CHANGE ORDER

PROJECT: Williamson County Justice Center Renovations
405 Martin Luther King Drive
Georgetown, Texas 78626

CHANGE ORDER NO: 009
DATE: March 11,2022
PROJECT NO: T1499-2020
CONTRACT DATE: Oct 27, 2020
CONTRACT FOR: General Construction

REVISED DRAWINGS – ASI-3 (TO BE REPLACED IN DRAWINGS ISSUED FOR ASI-2 ON 12/17/2020)

1 LEVEL 1 - COUNTY ATTORNEY - DEMOLITION PLAN
SCALE: 1/8" = 1'-0"

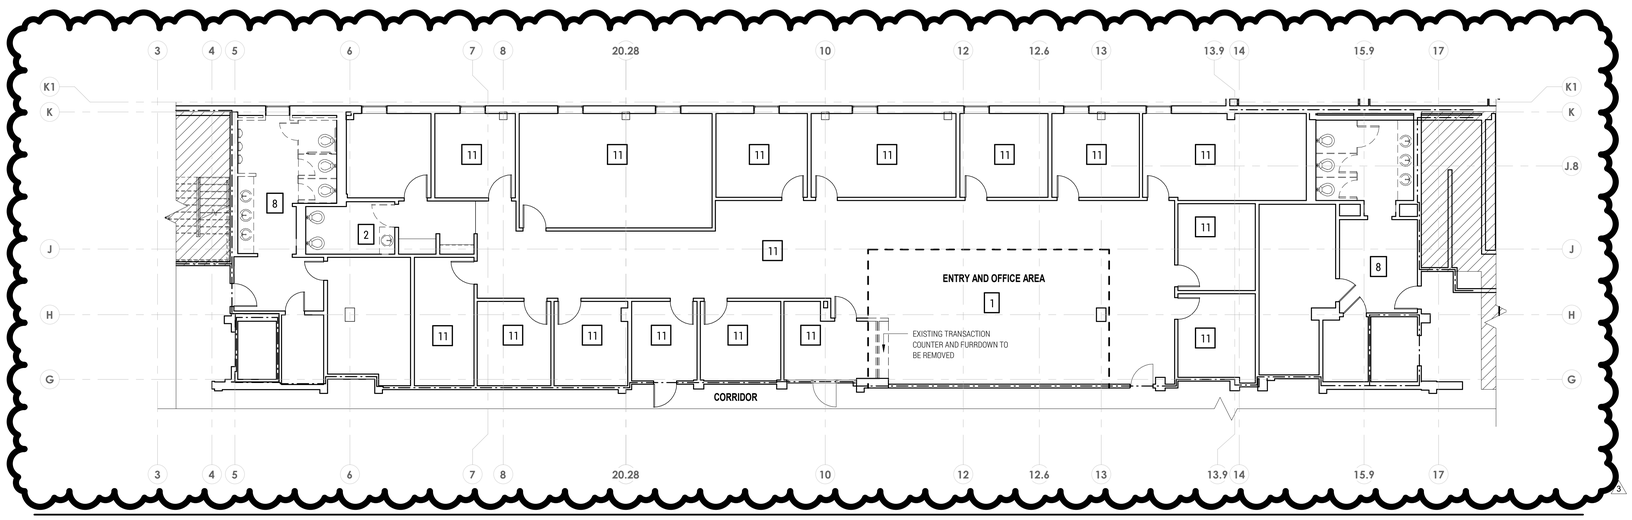
Item No. 1
A-105 Enlarged Demolition Plans
- The floor plan and notes were revised to include carpet removal in existing offices at - Level 1 County Attorney – See note 11 - Remove existing flooring and prepare for new.

11 REMOVE EXISTING FLOORING AND PREPARE FOR NEW

1 LEVEL 2 - DISTRICT ATTORNEY - DEMOLITION PLAN
SCALE: 1/8" = 1'-0"

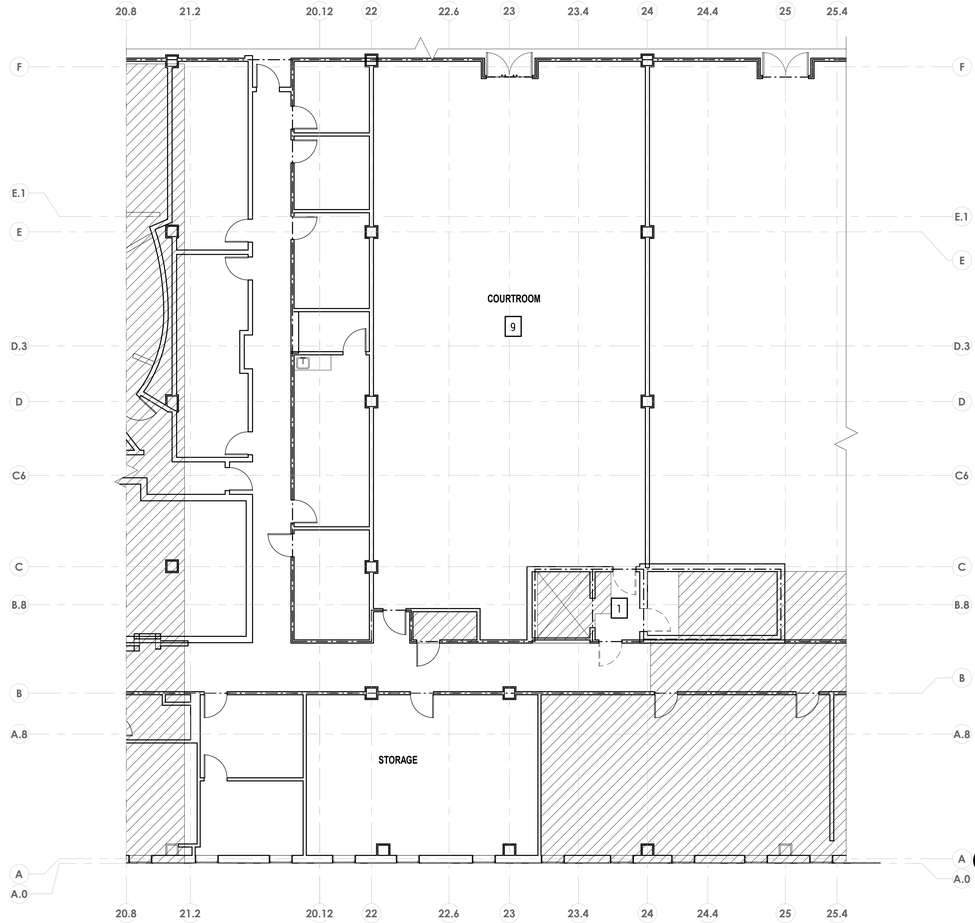
Item No. 2
A-106 Enlarged Demolition Plans
- The floor plan and notes were revised to keep existing flooring in certain offices at - Level 2 District Attorney – See Note 10 - Remove existing light fixture and prep for new (Existing flooring to remain)

10. REMOVE EXISTING LIGHT FIXTURES AND PREP FOR NEW (EXISTING FLOORING TO REMAIN)

1 BASEMENT - JURY CALL - DEMOLITION PLAN
SCALE: 1/8" = 1'-0"

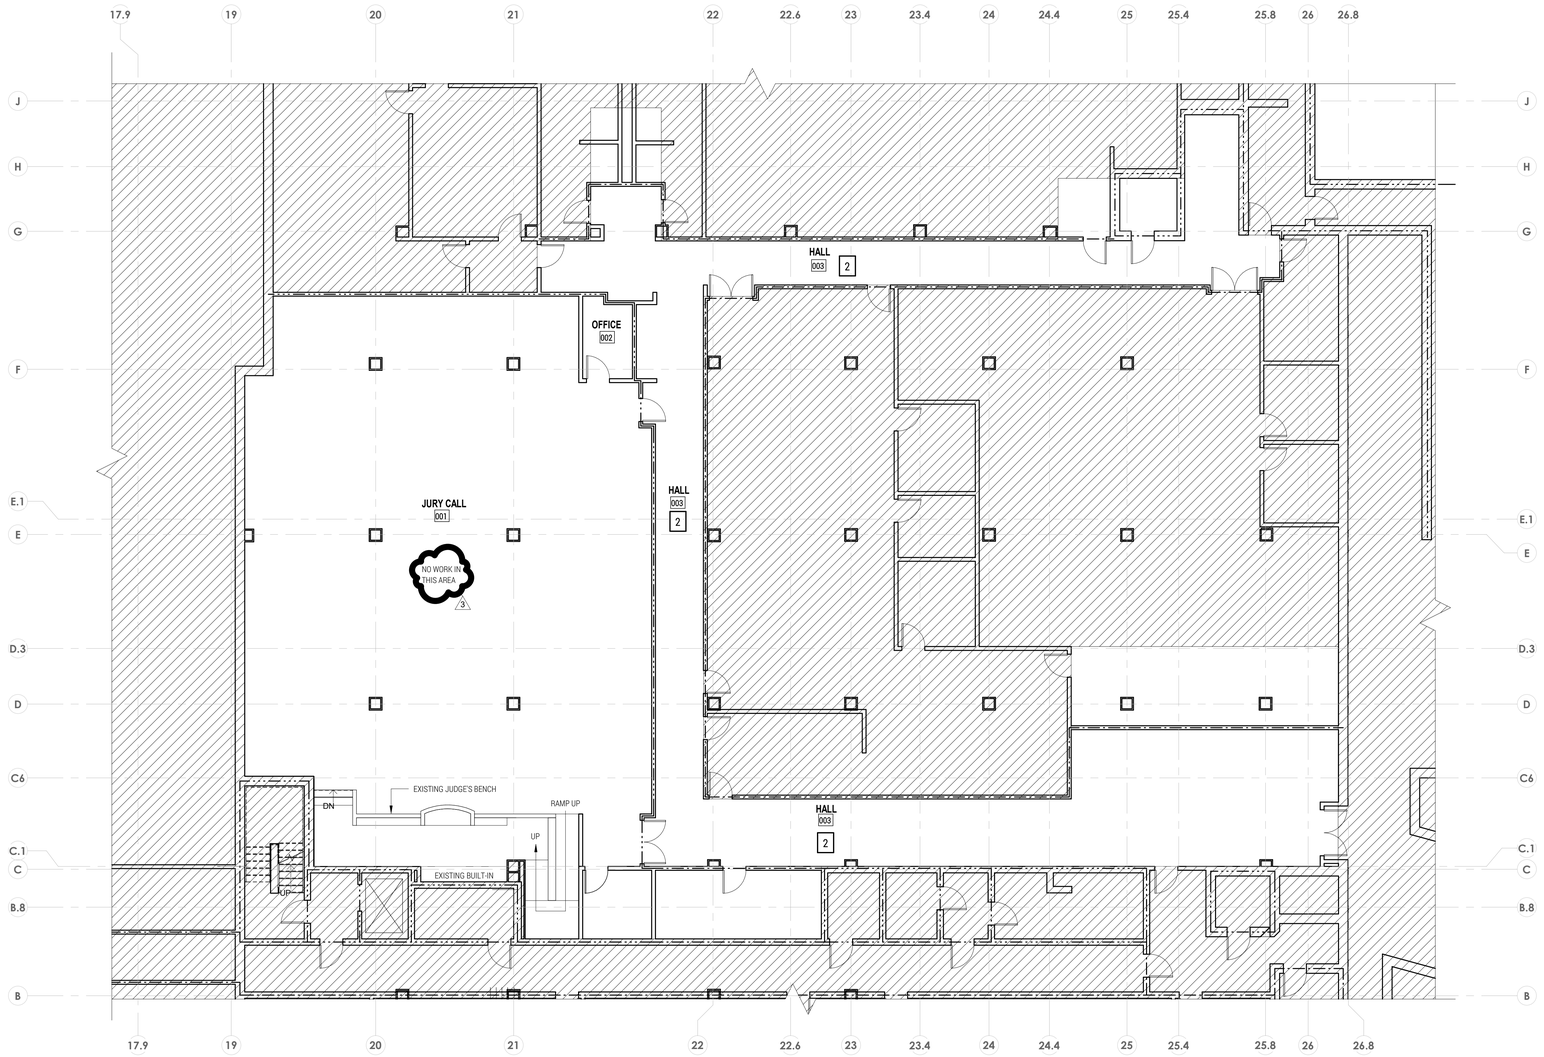
Item No. 3
A-109 Basement and Attic Demolition Plans
- The floor plan and notes were revised at - Basement Jury Call – See Note no. 1 – Not Used (New carpet, new ceiling grid, new light fixtures, and improvements to the existing judge's bench were removed from original scope).

1 BASEMENT - JURY CALL NEW CONSTRUCTION
SCALE: 1/8" = 1'-0"

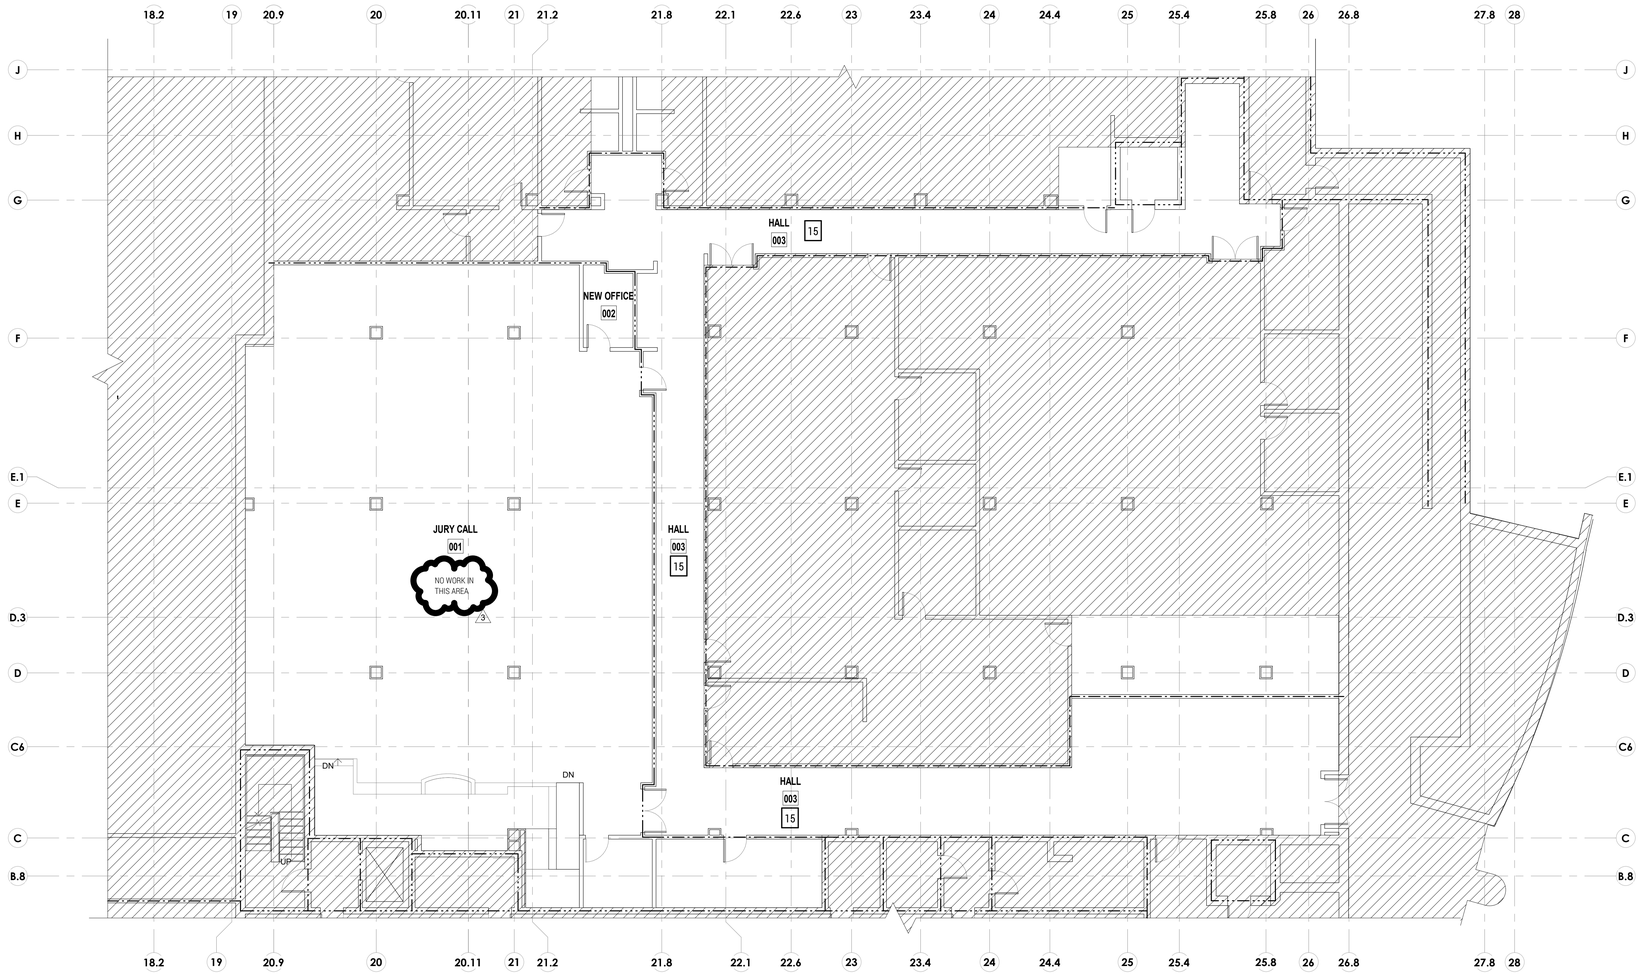
Item No. 4
A-114 Enlarged Plans
- The floor plan was revised at - Basement Jury Call – See Note no. 13 Not Used (New carpet, new ceiling grid and tile, new light fixtures, and improvements to existing Judge's bench were removed from original scope).

- The floor plan was revised at - Basement Jury Call– Jury call 001 and New Office 002 no longer in scope.

1 LEVEL 1 - COUNTY ATTORNEY - NEW CONSTRUCTION
SCALE: 1/8" = 1'-0"

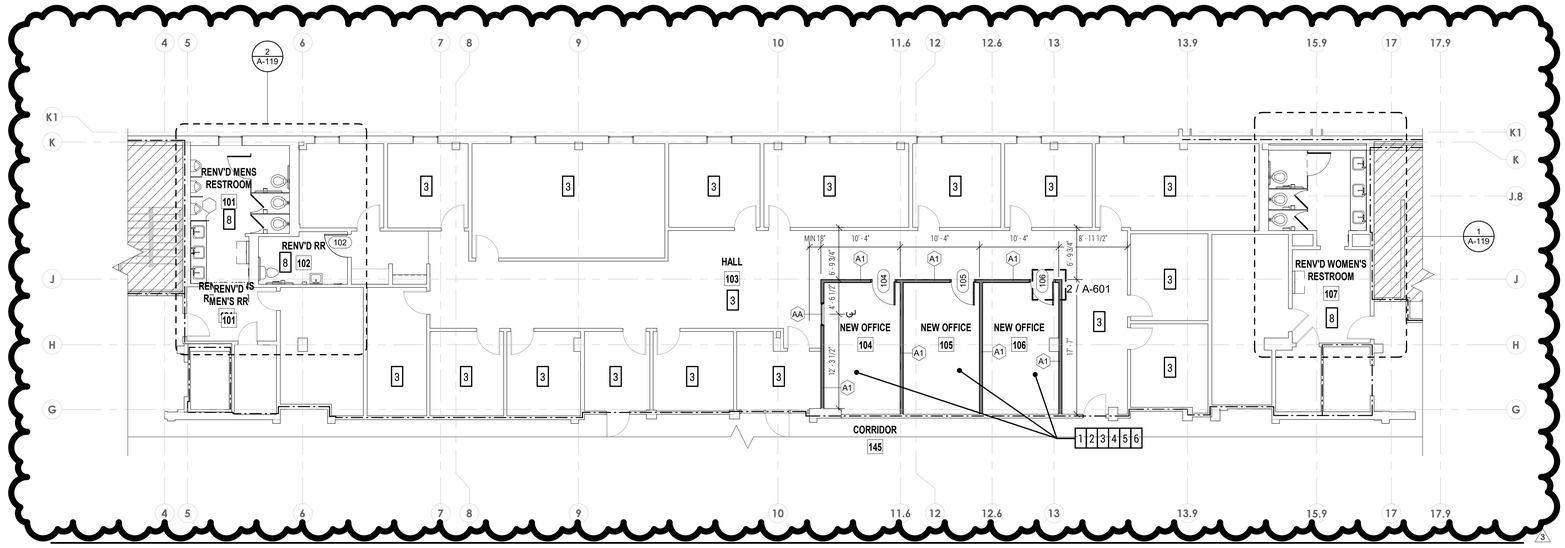
Item No. 5
A-115 Enlarged Plans
- The floor plan was revised to include new carpet in existing hallway and offices - Level 1 County Attorney – See Note no. 3 – Provide new flooring; refer to finish schedule.

- The floor plan was revised at - Level 1 County Attorney – New carpet at existing offices and hallway added to scope.

1 LEVEL 1 - COURTROOM NEW CONSTRUCTION
SCALE: 1/4" = 1'-0"

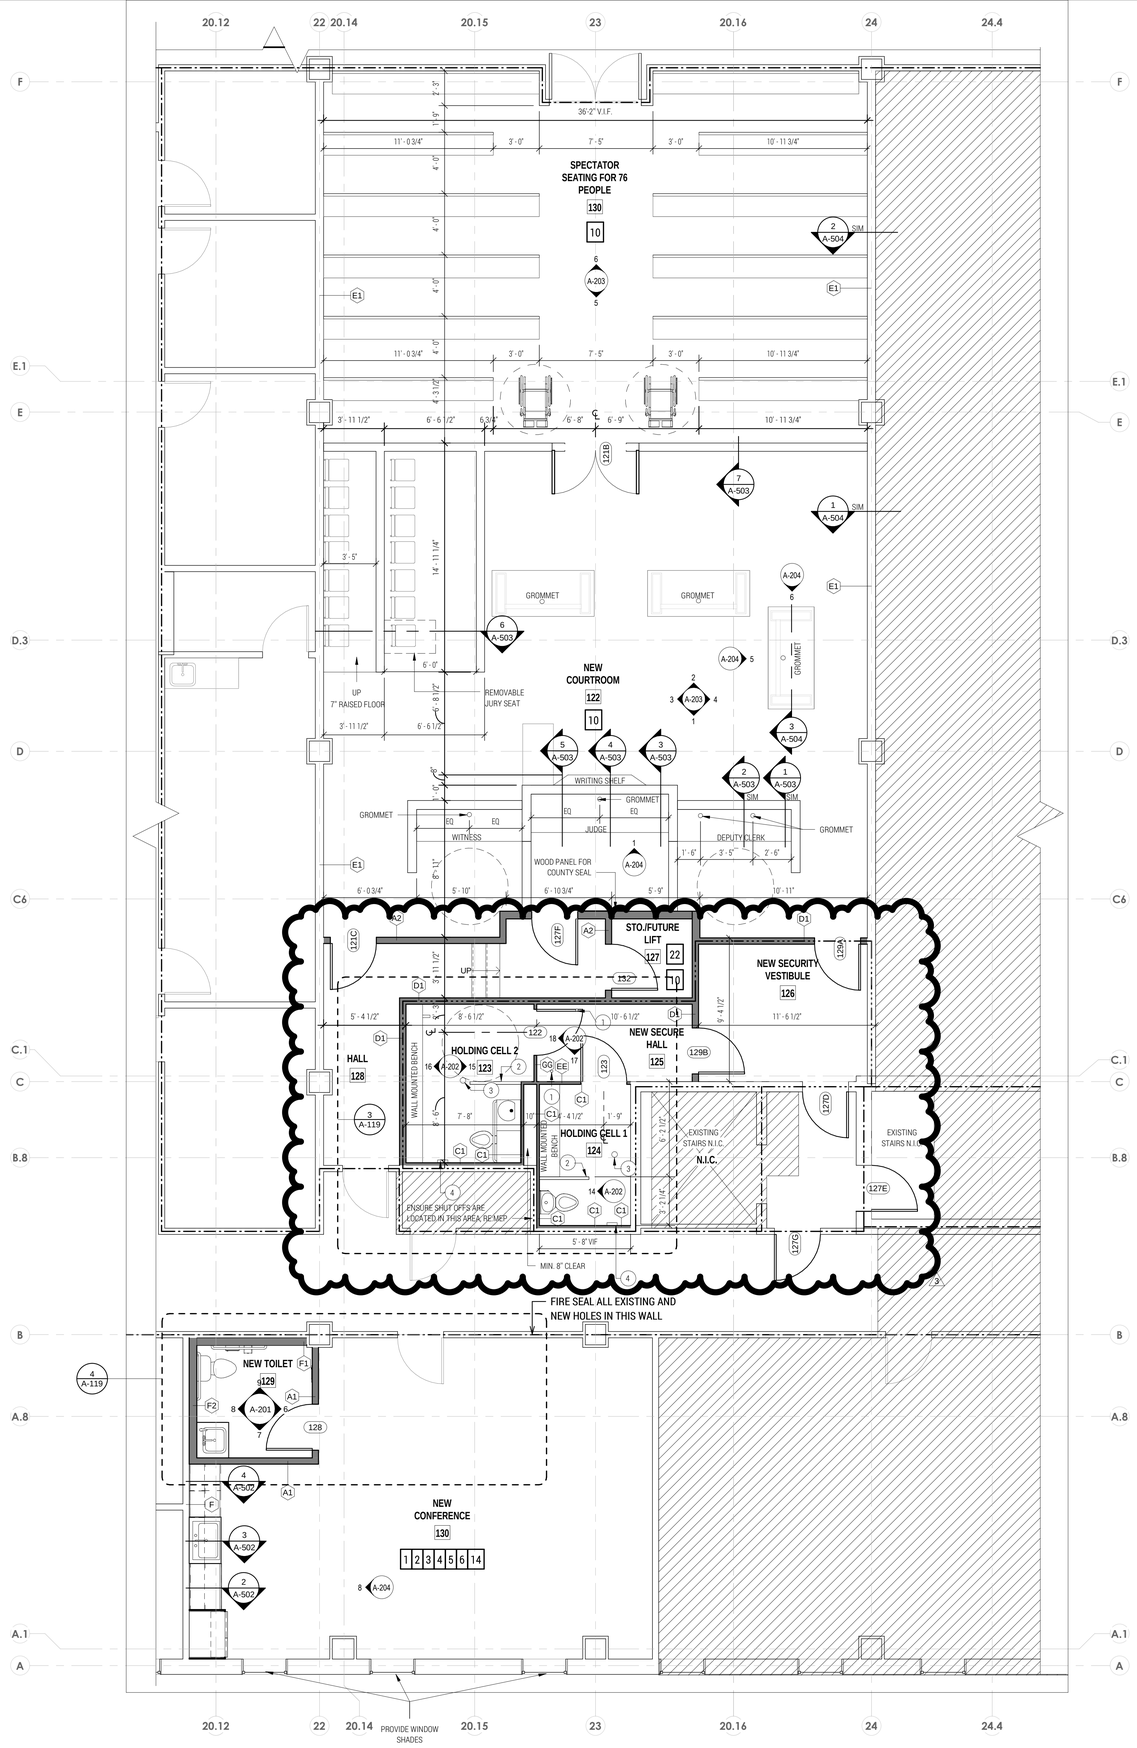
- The floor plan was revised at - Level 1 Courtroom - Holding Cell 1 has been reconfigured. Refer to RFIs 14 and 16.

1 LEVEL 2 - DISTRICT ATTORNEY NEW CONSTRUCTION
SCALE: 1/8" = 1'-0"

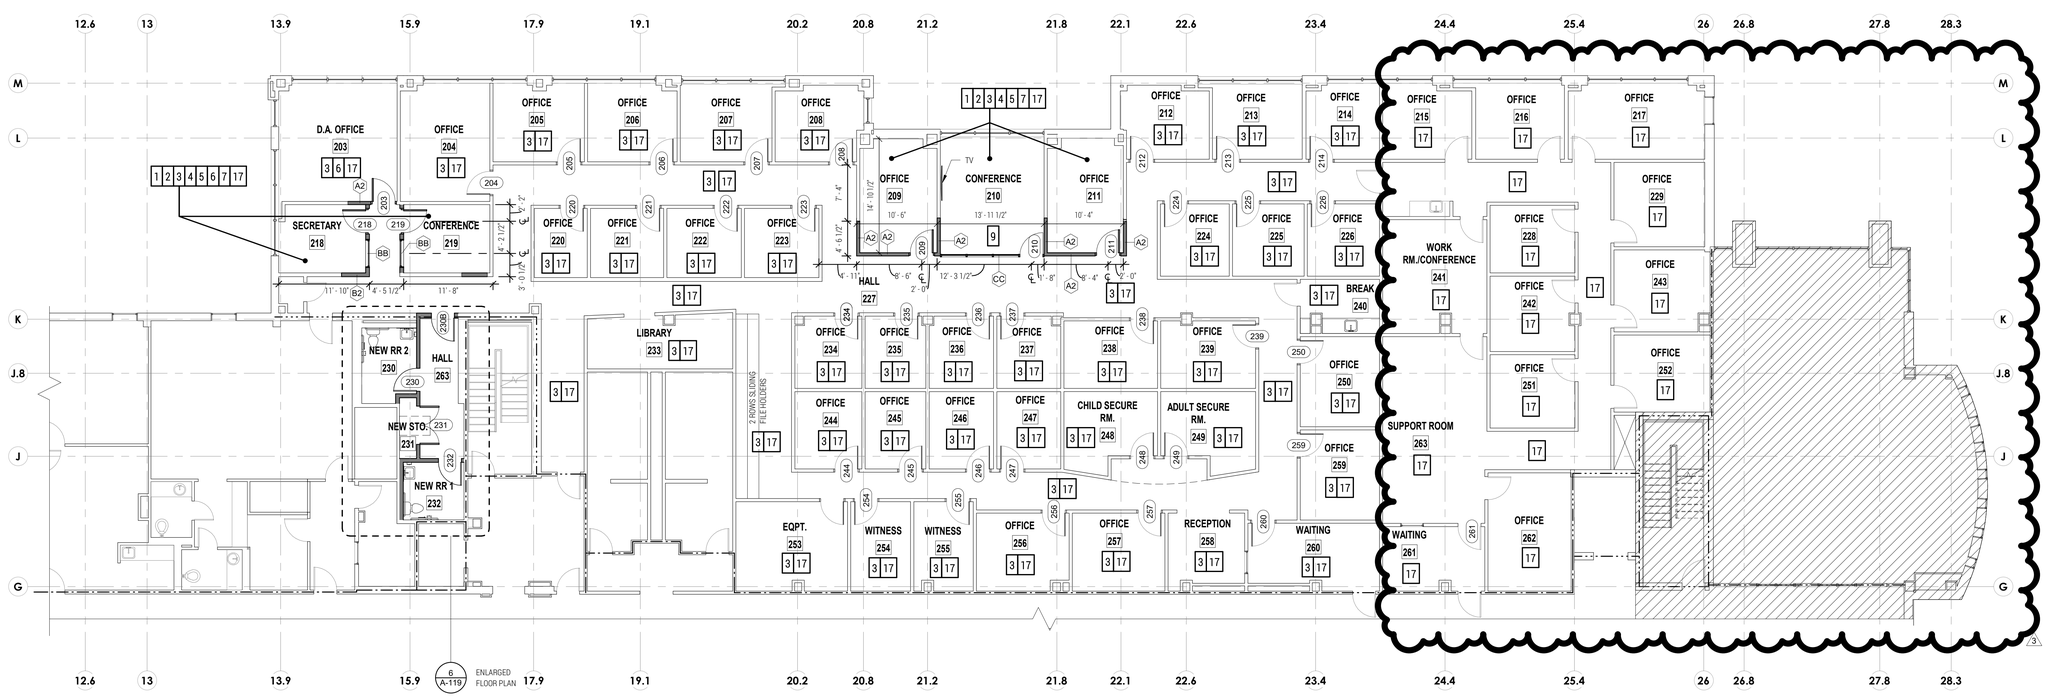
- The floor plan was revised at - Level 2 District Attorney – New carpet removed from scope at certain offices indicated. (Existing carpet to remain in Rooms 215, 216, 217, 228, 229, 241, 242, 243, 251, 252, 261, 262, 263, and adjacent hallway).

1 BASEMENT - RCP - JURY CALL
SCALE: 1/8" = 1'-0"

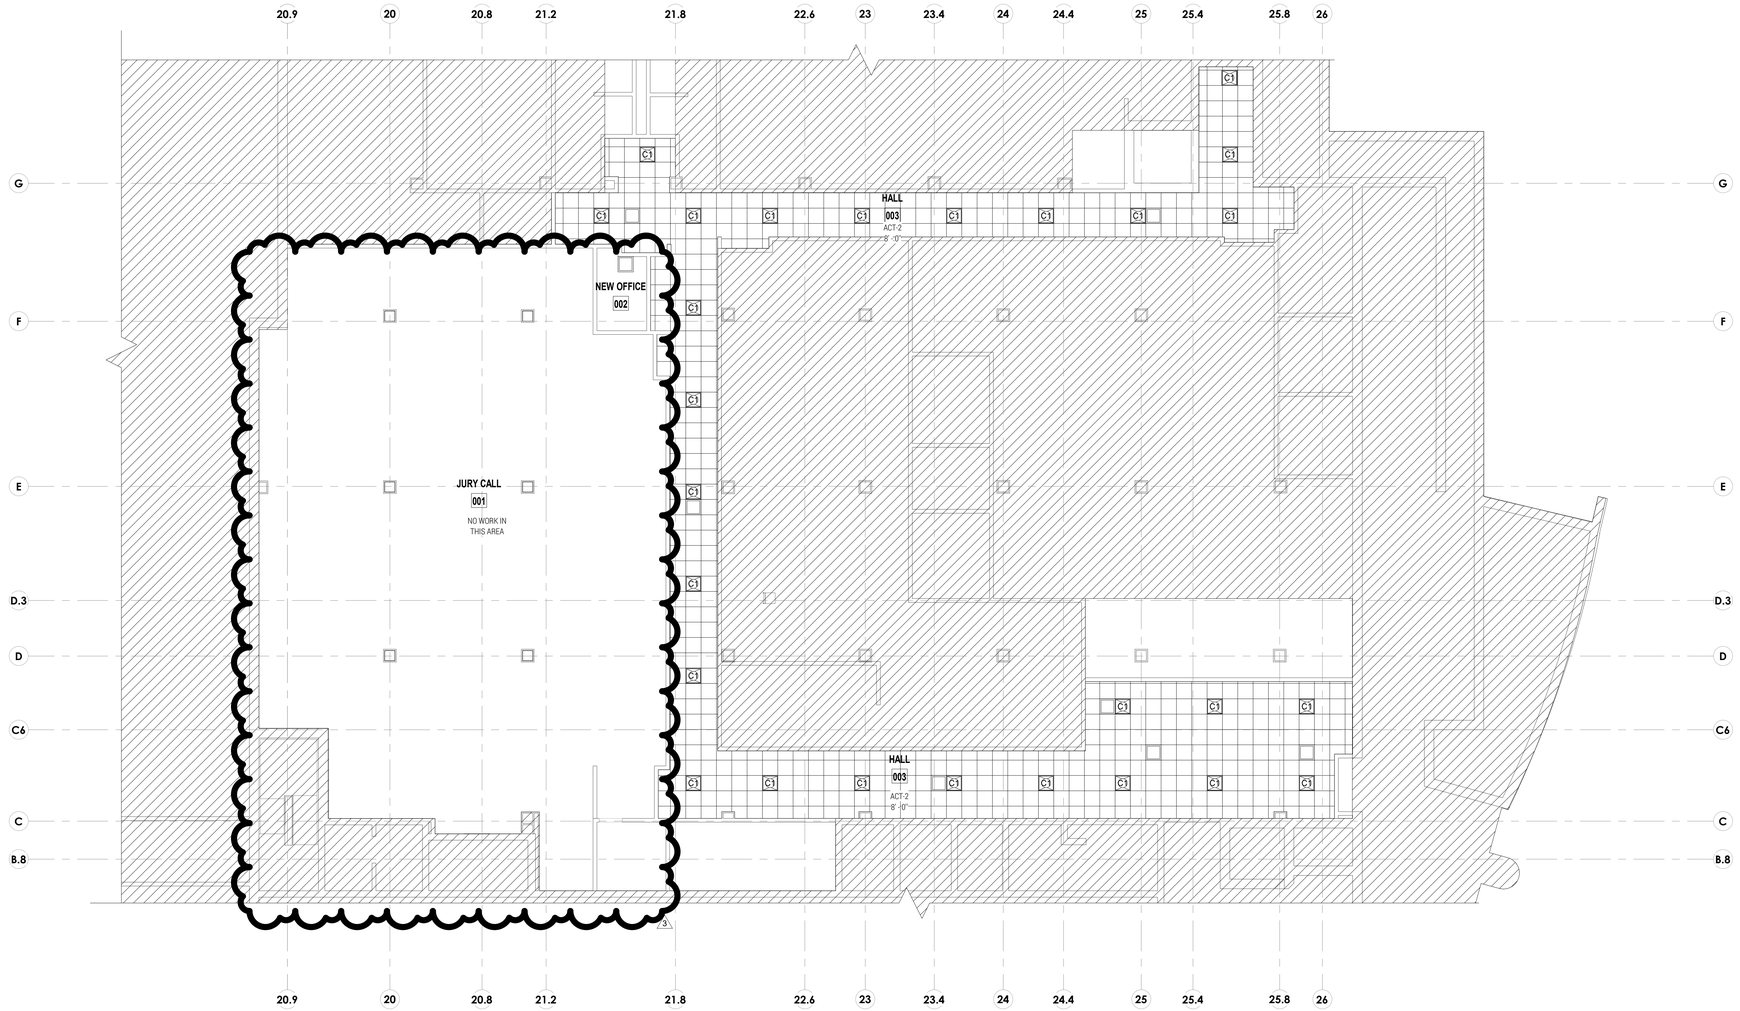
- The floor plan was revised at - Basement RCP (1/A120) –New ceiling lights and grid are no longer in scope.
